**ADDENDUM NO. 1
TO THE
SPECIFICATIONS AND CONTRACT DOCUMENTS**

City Project No. FAC23008O

City Hall Generator

November 24th, 2025

S102

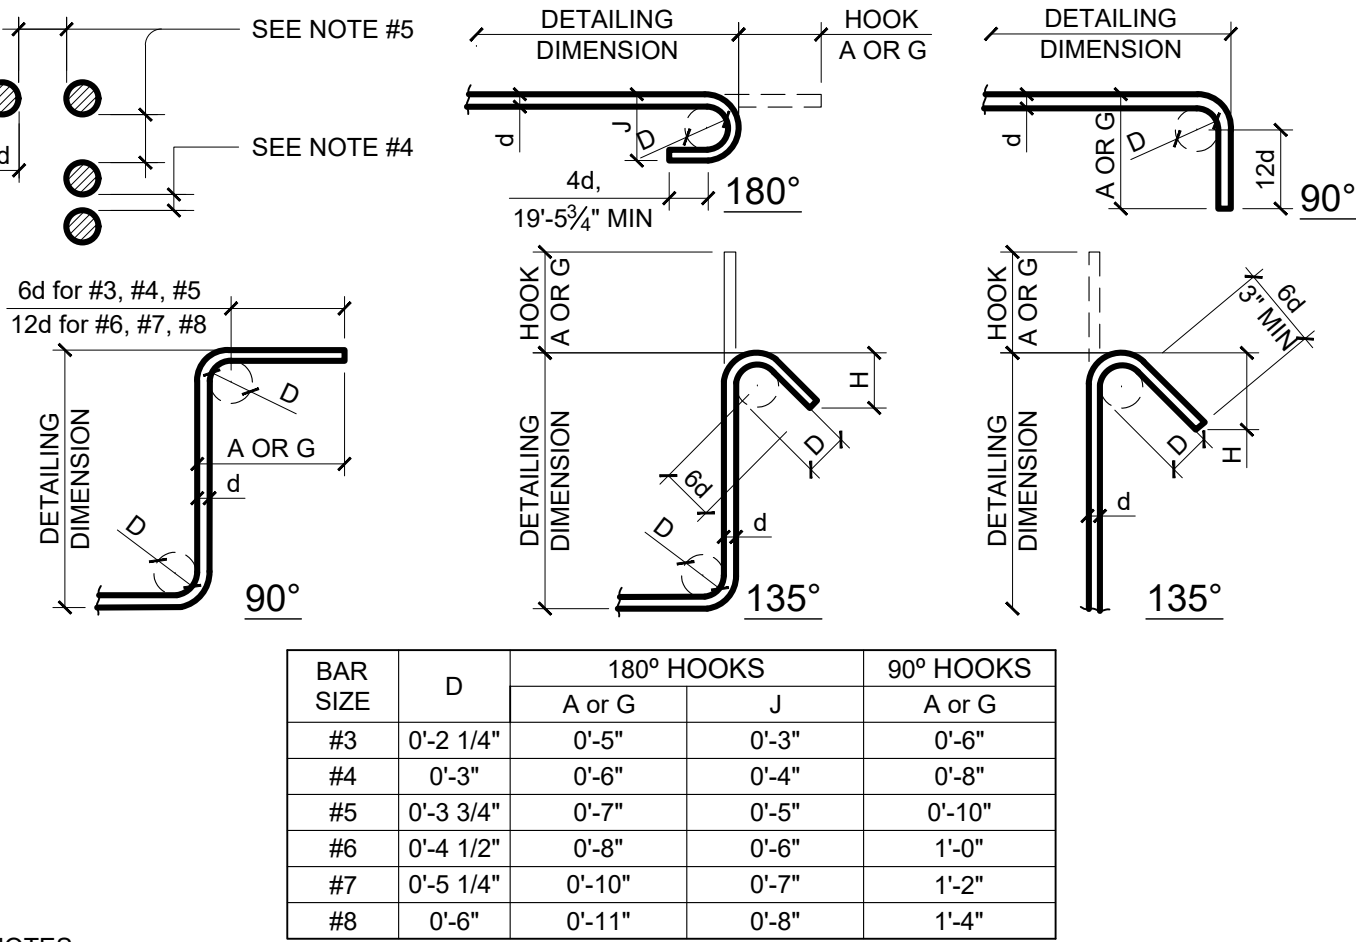
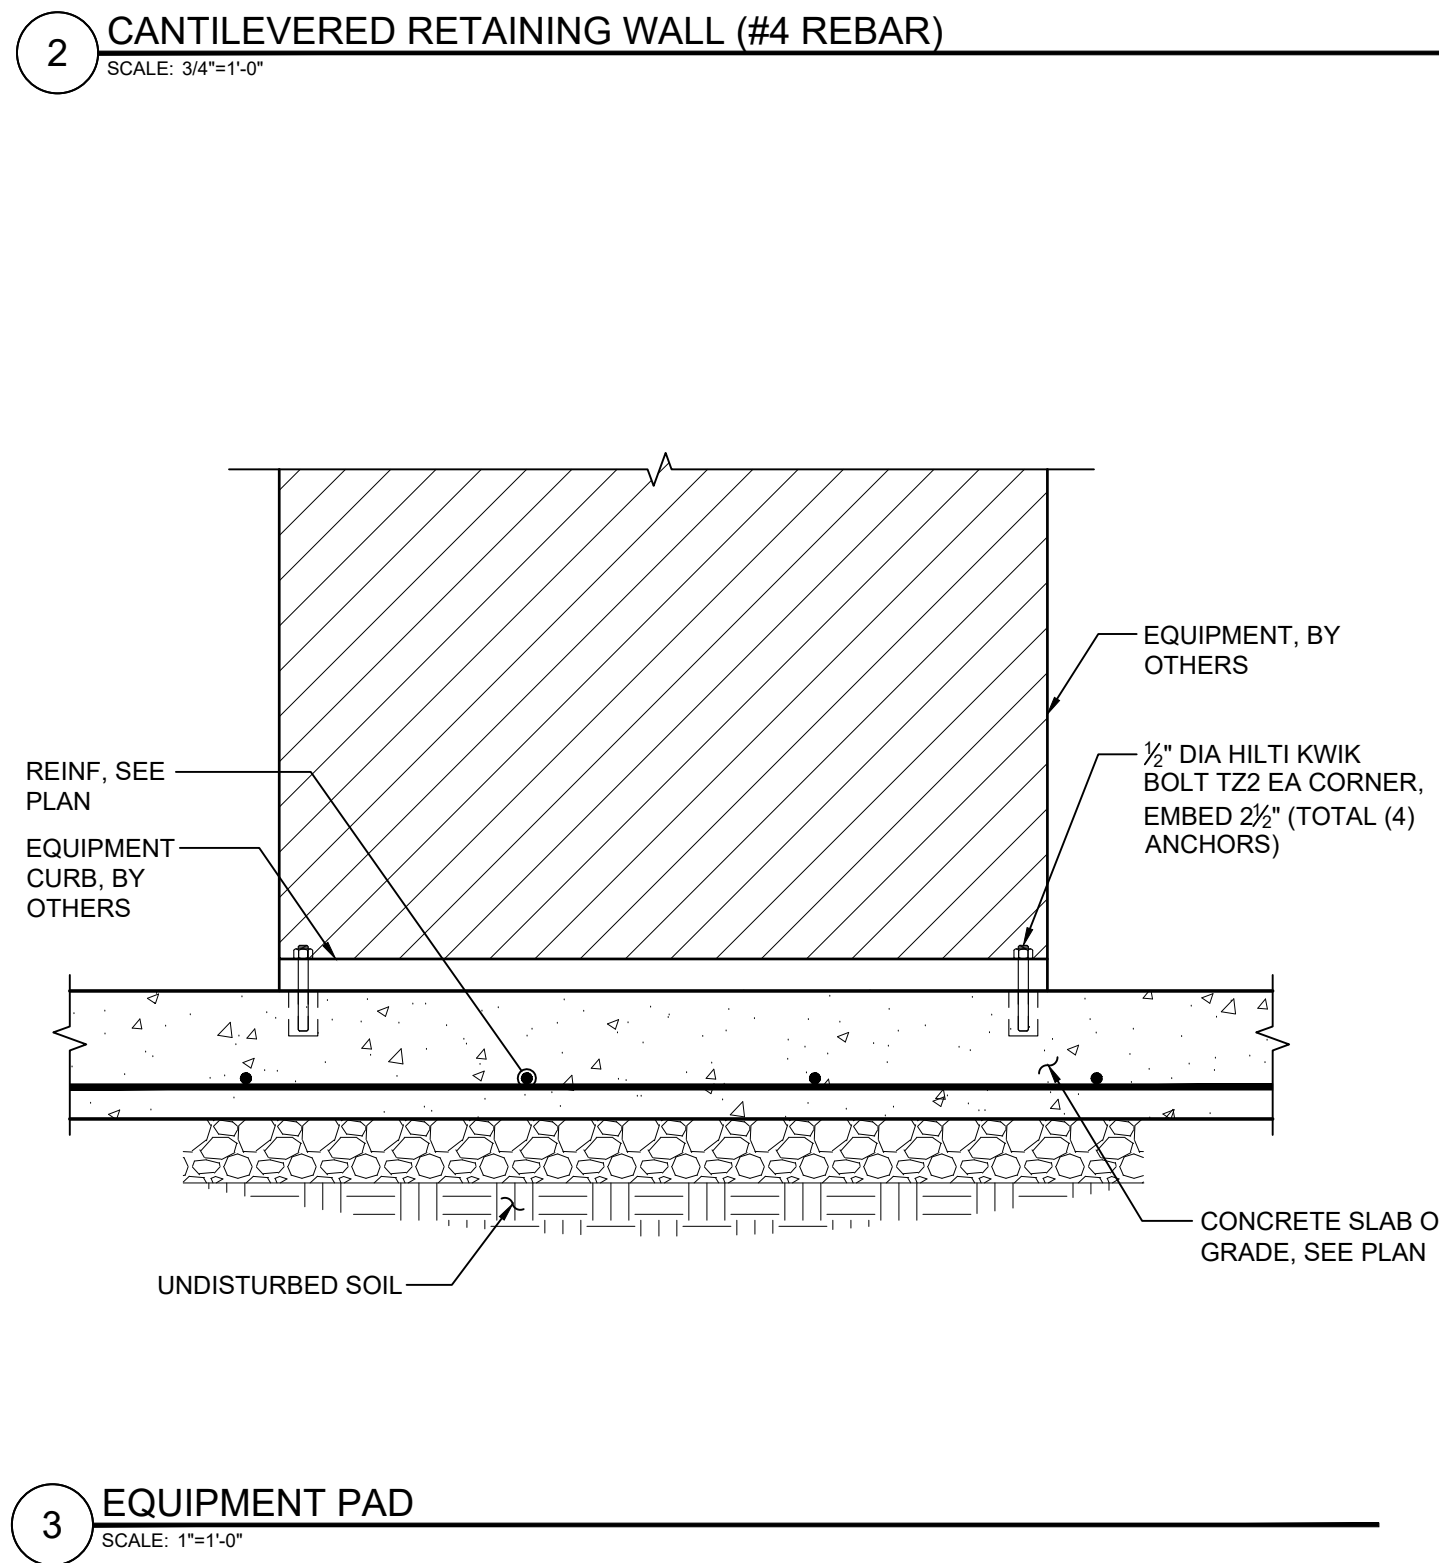
Structural Plan: The footing overall width is 1'-9". See revised structural plan sheet.

Structural Plan Sheets S102

Delete plan sheet S102 in its entirety and replace with revised plan sheet.
See attached plan sheet S102.

CANTILEVERED RETAINING WALL SCHEDULE								
WALL MARK	H(MAX)	ts	FOOTING (INCLUDES ts)	tf	WALL REINF		FTG REINF	
					VERT	HORIZ	TOP TRANSVERSE	TOP LONGITUDINAL
A	3'-0"	6"	1'-9"	12"	#4 AT 16" OC	#4 AT 16" OC	#4 AT 9" OC	(3) #4
